## 7C Defense Against Common-Mode Failure in Safety-Related, Software-Based I&C Systems

The information in this appendix of the reference ABWR DCD, including all subsections and figures, is incorporated by reference with the following departures.

STD DEP T1 3.4-1 (Figure 7C-1)

Figure 7C-1 Implementation of Additional Diversity in SSLC to Mitigate Effects of Common-Mode Failures

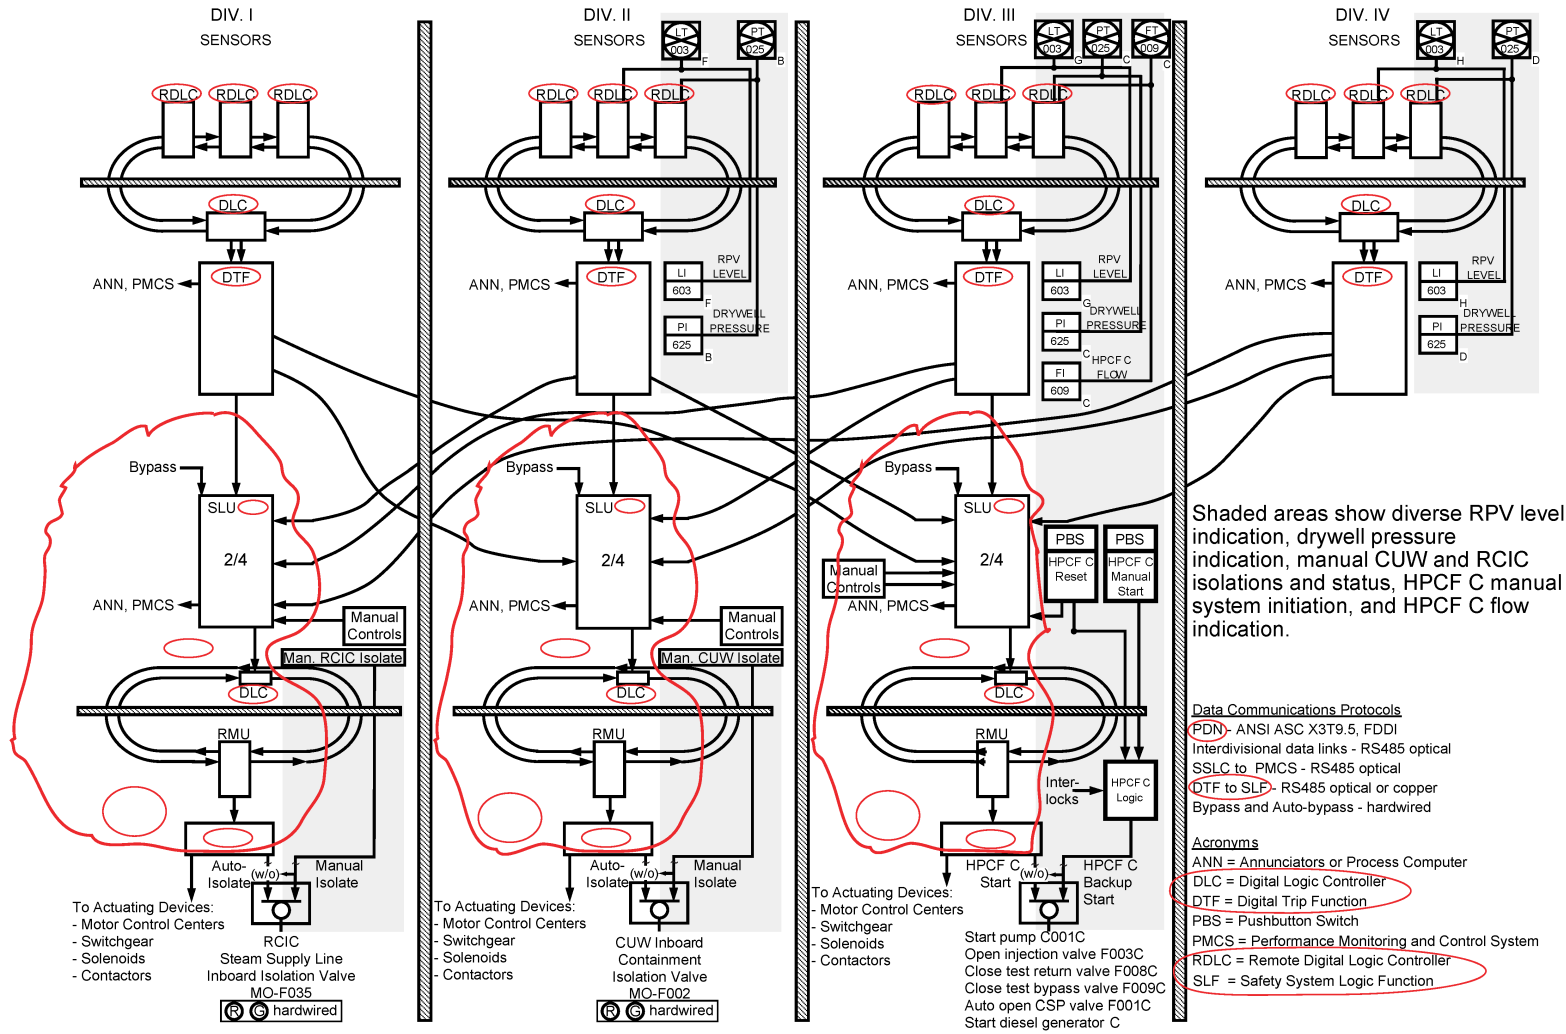
STD DEP T1 3.4-1 (Figure 7C-1)

*The SSLC design also uses hardwired control switches to perform manual system start of the other systems in ECCS. However, these switches are hardwired only from the operator's control station to the microprocessor logic in SSLC, where ~~EMS ECF~~ then provides the transmission path for control signals from SSLC to the actuated devices.*

Control switch signals for individual control of pumps and valves are multiplexed transmitted from the operator's control station to SSLC and then through EMS ECF as stated above.

- (2) Defense-in-depth configuration:
  - (a) Fail-safe RPS and fail-as-is ESF in separate processing channels
  - (b) Control systems ~~supporting diverse injection~~ are independent of RPS and ESF in separate triplicated processing network using diverse hardware and software from the ~~Essential Multiplexing System~~ Essential Communication Function (ECF) network
